Cumberland County Subdivision and Land Development Review Report

Municipality:	<u>Silver Spring</u>	Surveyor/ Engineer:	<u>Alpha Consulting Engineers, Inc.</u>	Owner/ Developer:	<u>Linlo Properties</u>
Plat Title:	<u>200 Bent Creek Blvd</u>				
Plat Status:	<u>Final</u>	Plat Type:	<u>Land Development</u>		
# of New Lots:	<u>0</u>	# of New Dwelling Units:	<u>0</u>	New Acreage Subdivided/Developed:	<u>2.02</u>
				Total Tract Acreage:	<u>2.02</u>
Zoning District:	<u>C-2</u>	Proposed Land Use:	<u>Office</u>		
Date Received:	<u>1/17/2020</u>	County Review:	<u>01/28/2020</u>	Reviewed by:	<u>SH</u>
				Checked by:	<u></u>

FINAL LAND DEVELOPMENT PLAN FOR 200 BENT CREEK BOULEVARD

FINAL LAND DEVELOPMENT PLAN
 SITE PLAN

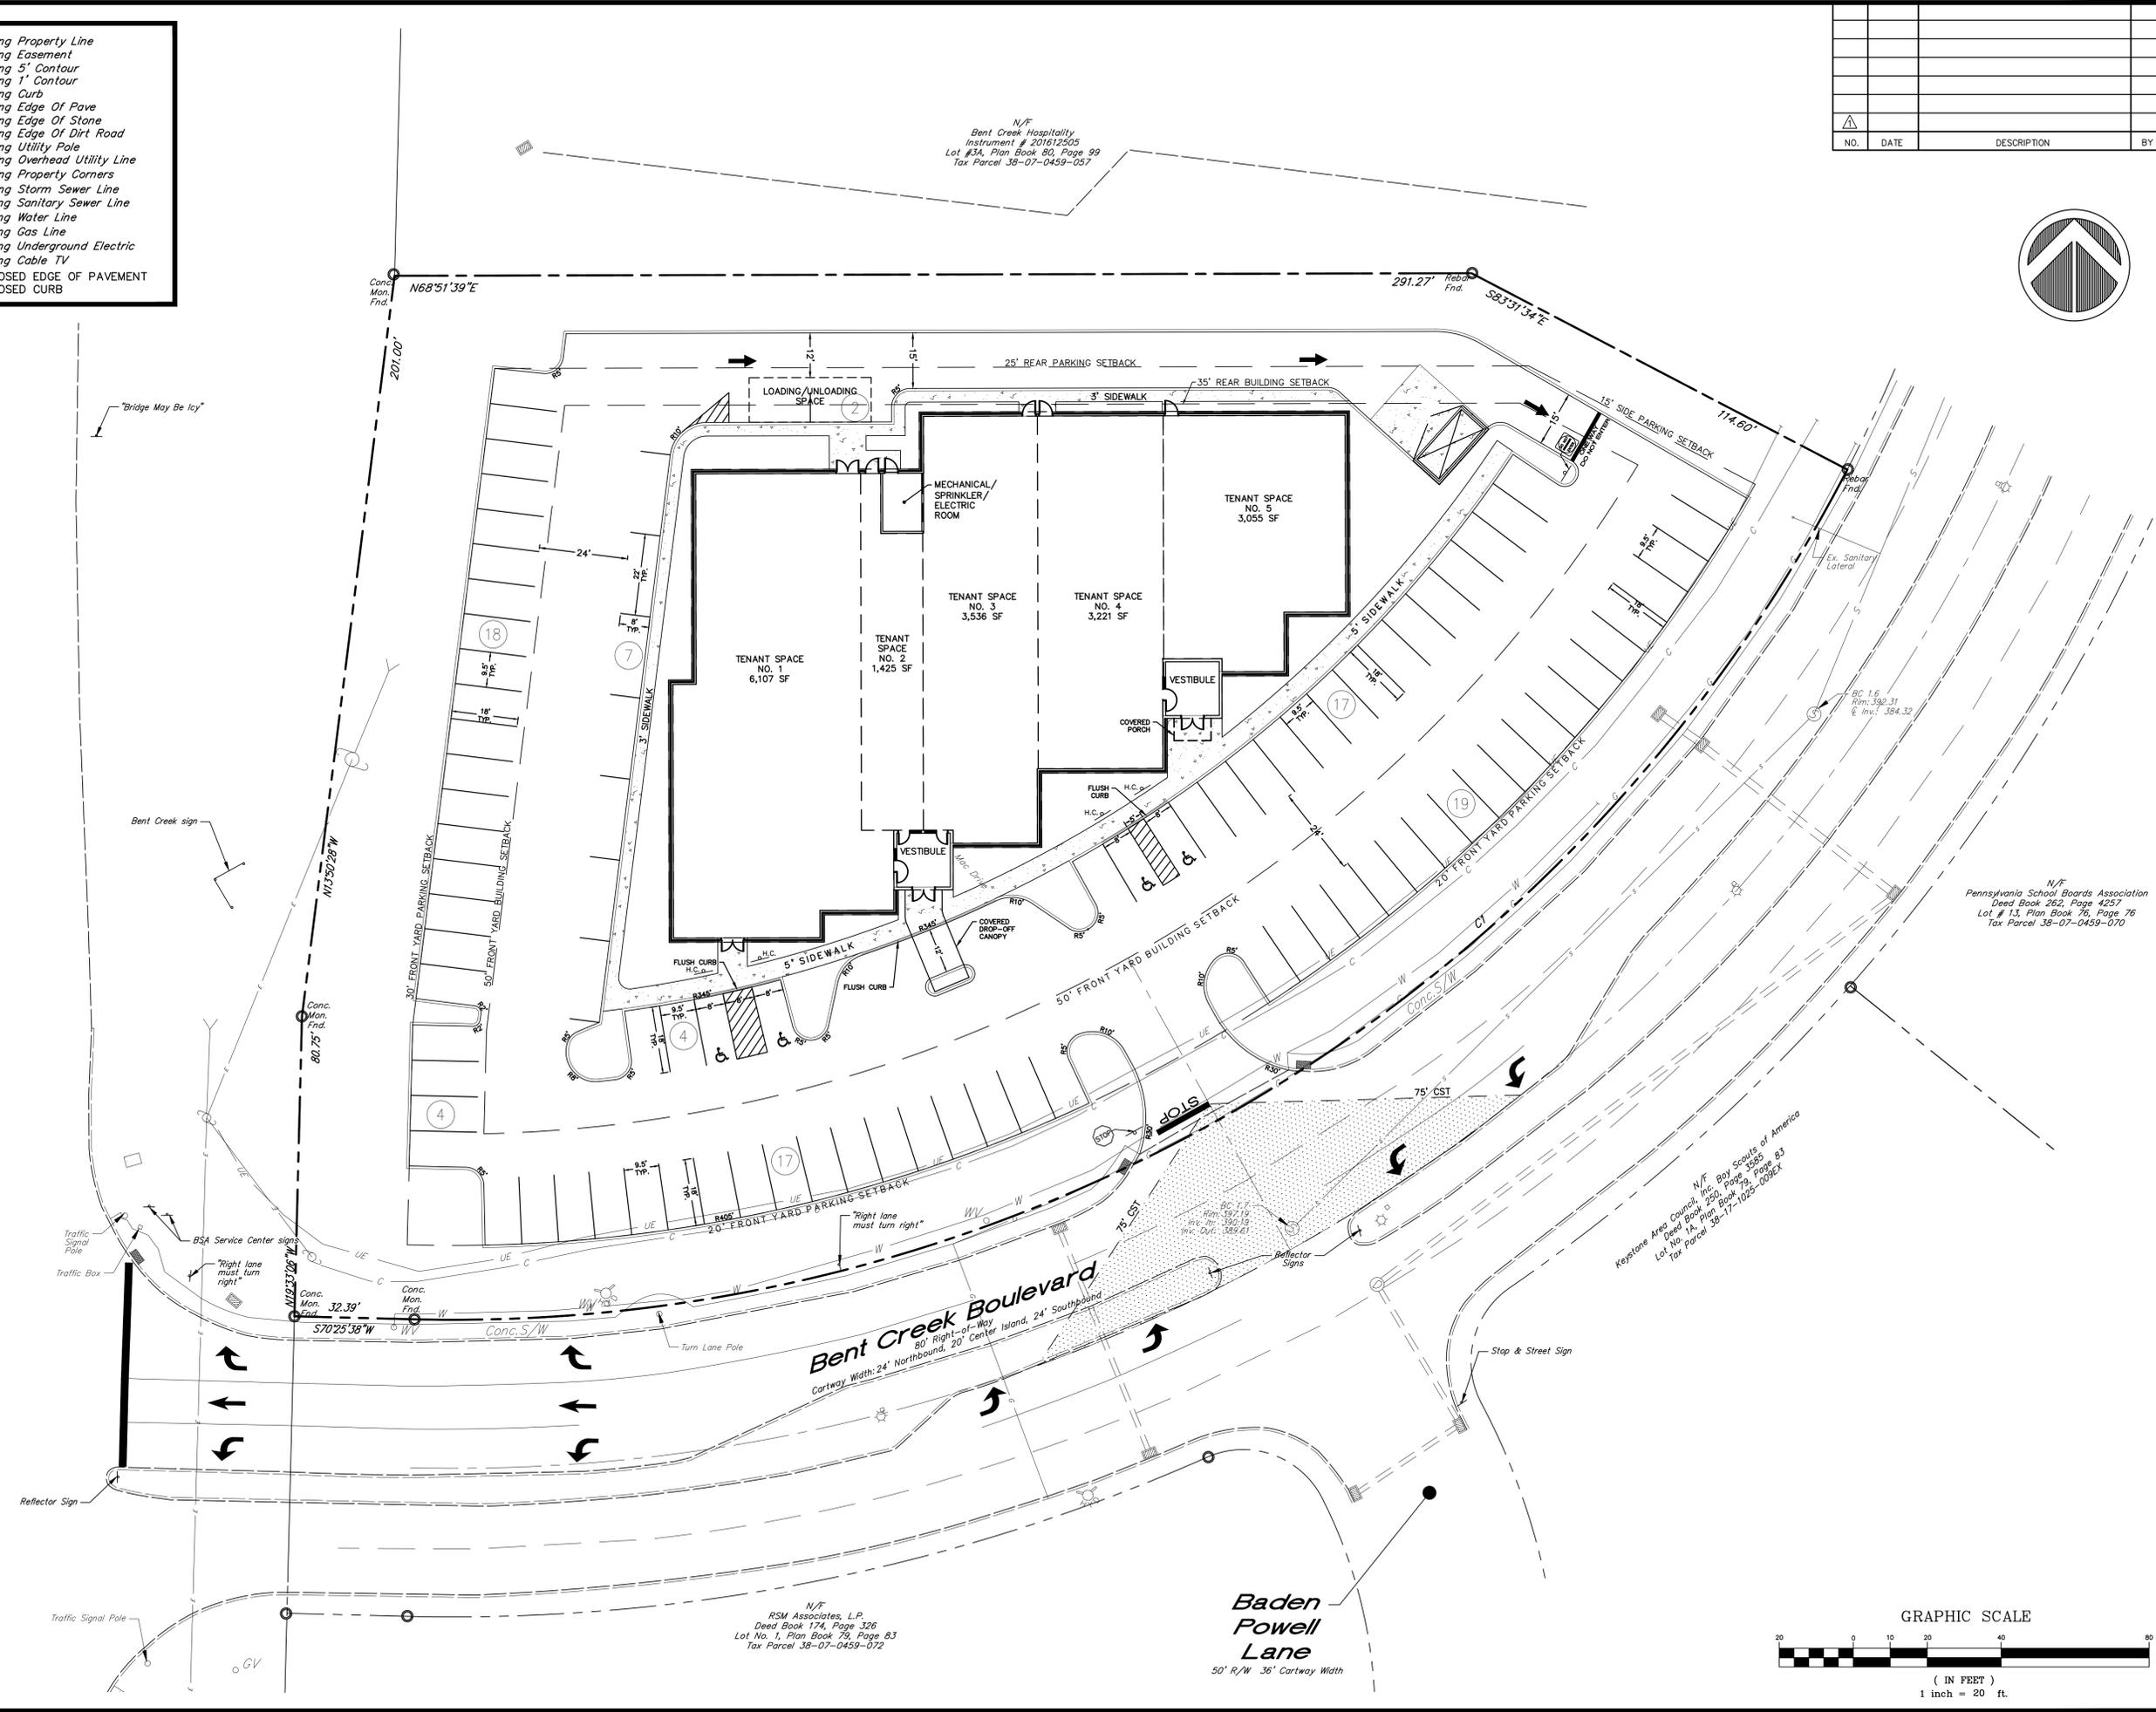
3. A crosswalk should be shown at the access drive (SLDO 402.04.4).
4. The required and provided sight distances should be provided at the access drive (SLDO 602.13).

7. Silver Spring Township has been mandated to recycle. Recommend providing a recycling dumpster for the development.
8. How will the owners and patrons of Tenant Space No. 5 access the building? It appears that the vestibule should include an additional door.

FINAL LAND DEVELOPMENT PLAN
 LANDSCAPE & LIGHTING PLAN
200 BENT CREEK BLVD
 SILVER SPRING TOWNSHIP, CUMBERLAND COUNTY, PENNSYLVANIA

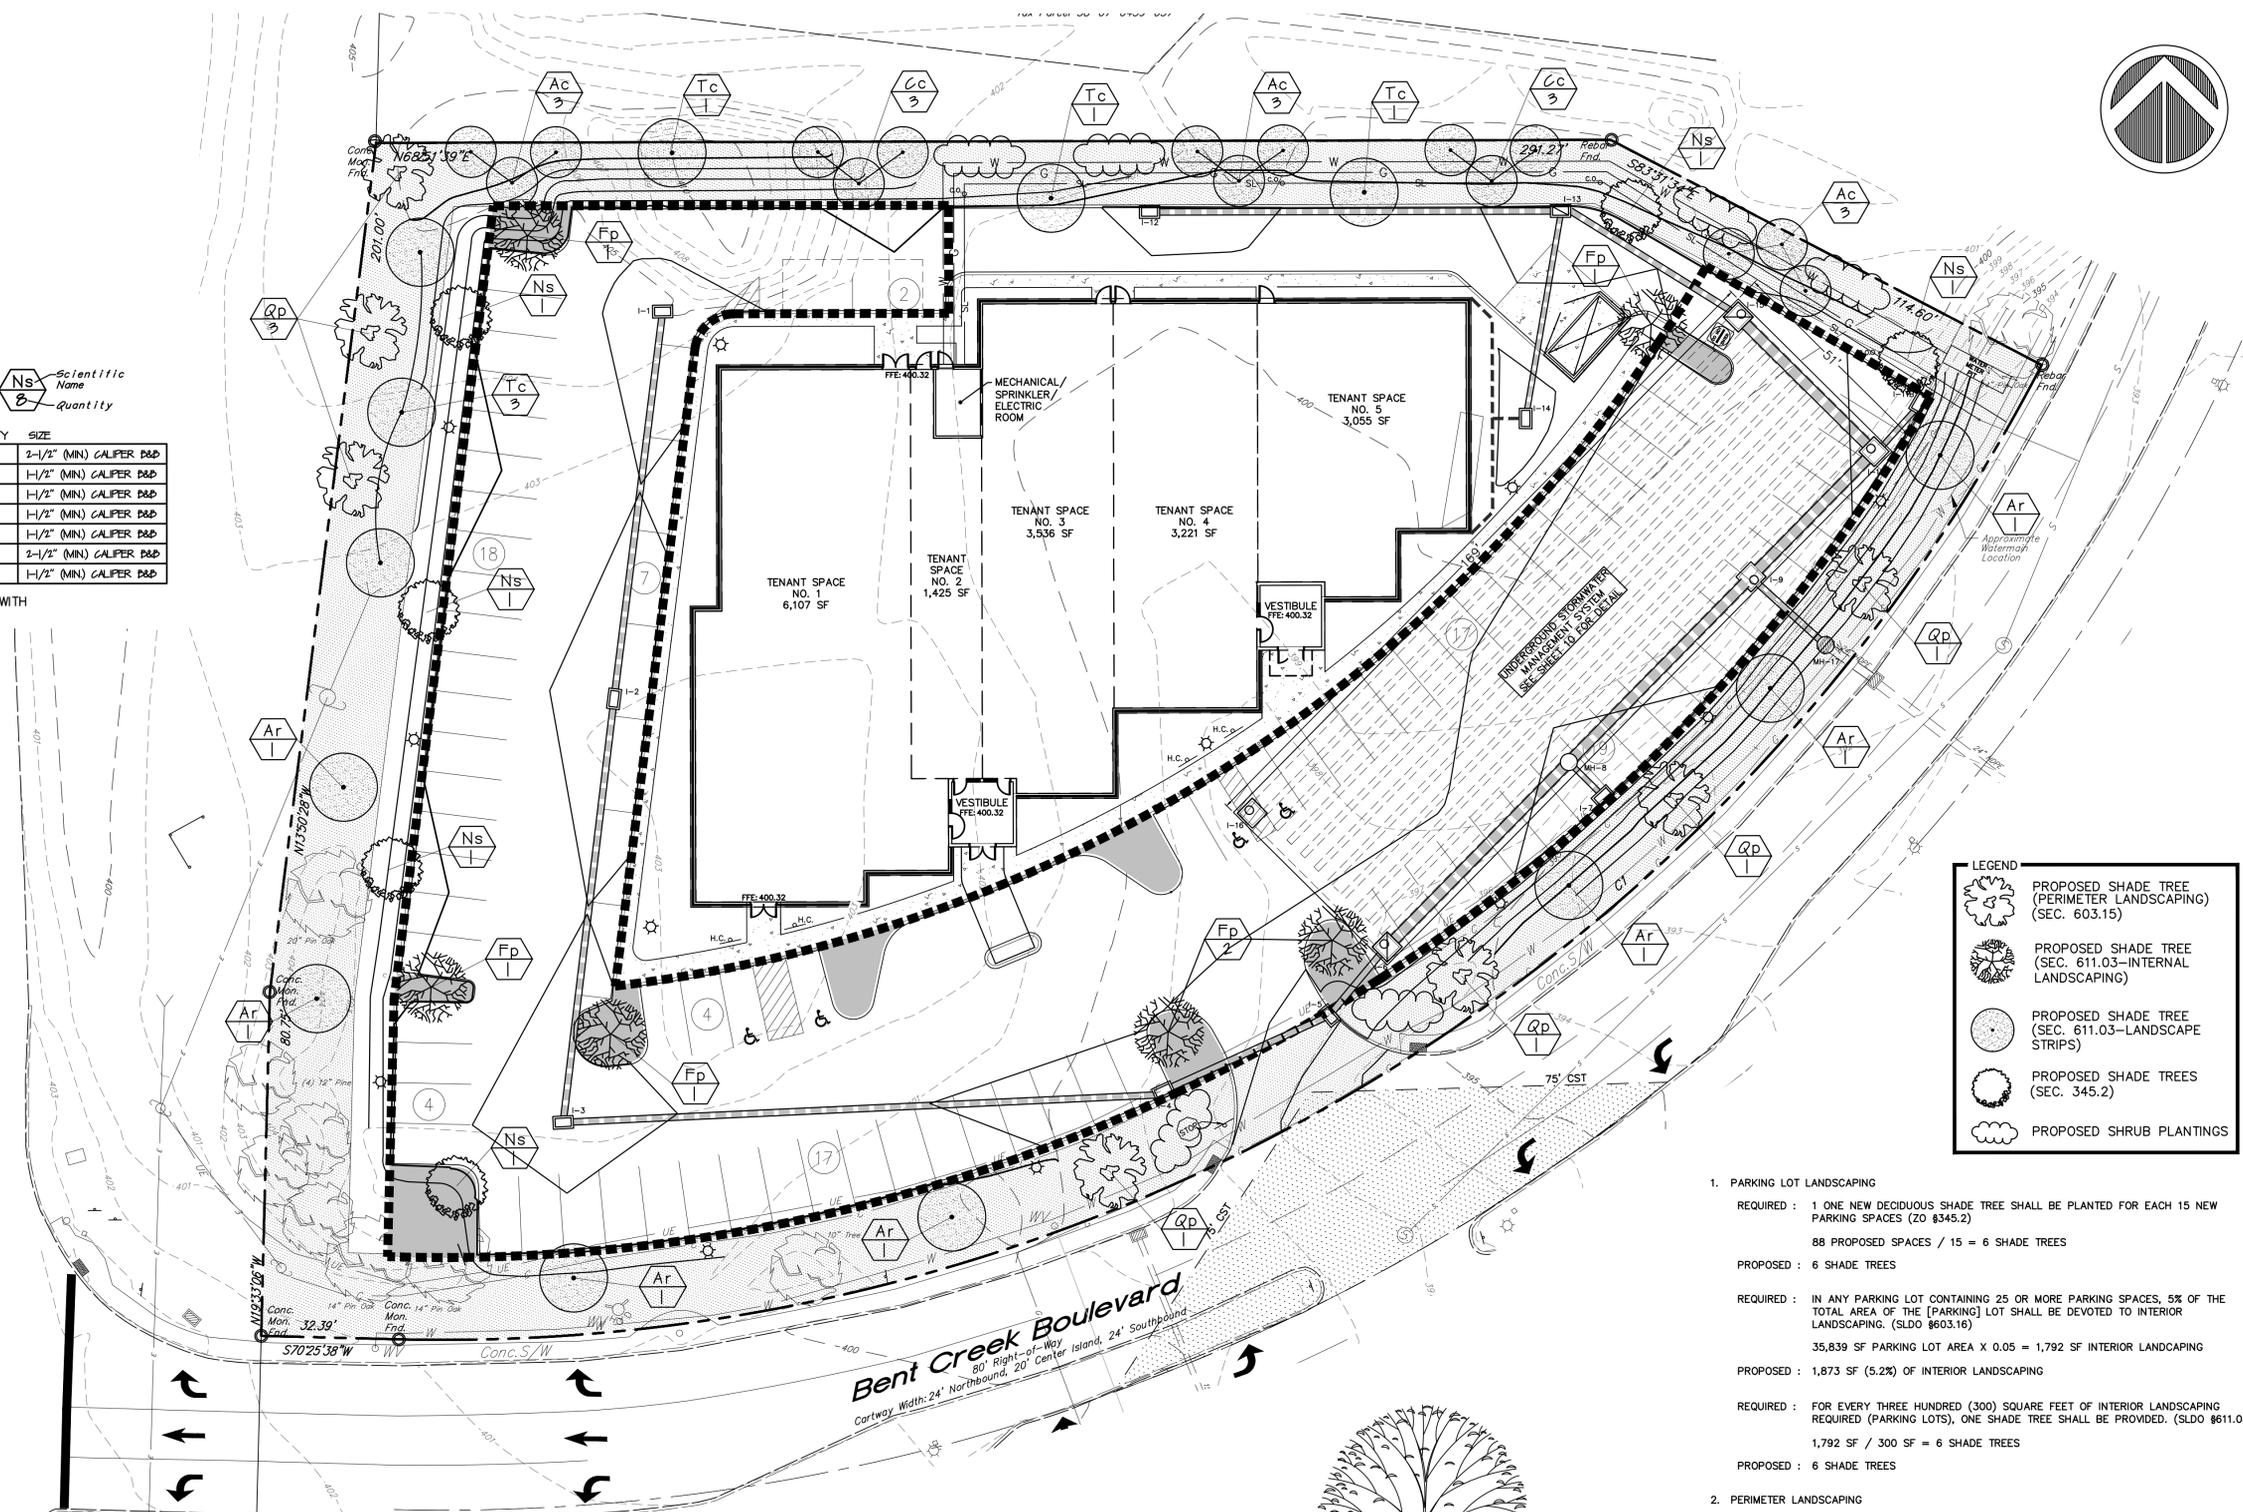
5. A lighting plan should be provided. The plan should provide candlepower measurements (SLDO 603.14).
6. An Erosion and Sedimentation Control Plan should be submitted to the Cumberland County Conservation District for review.
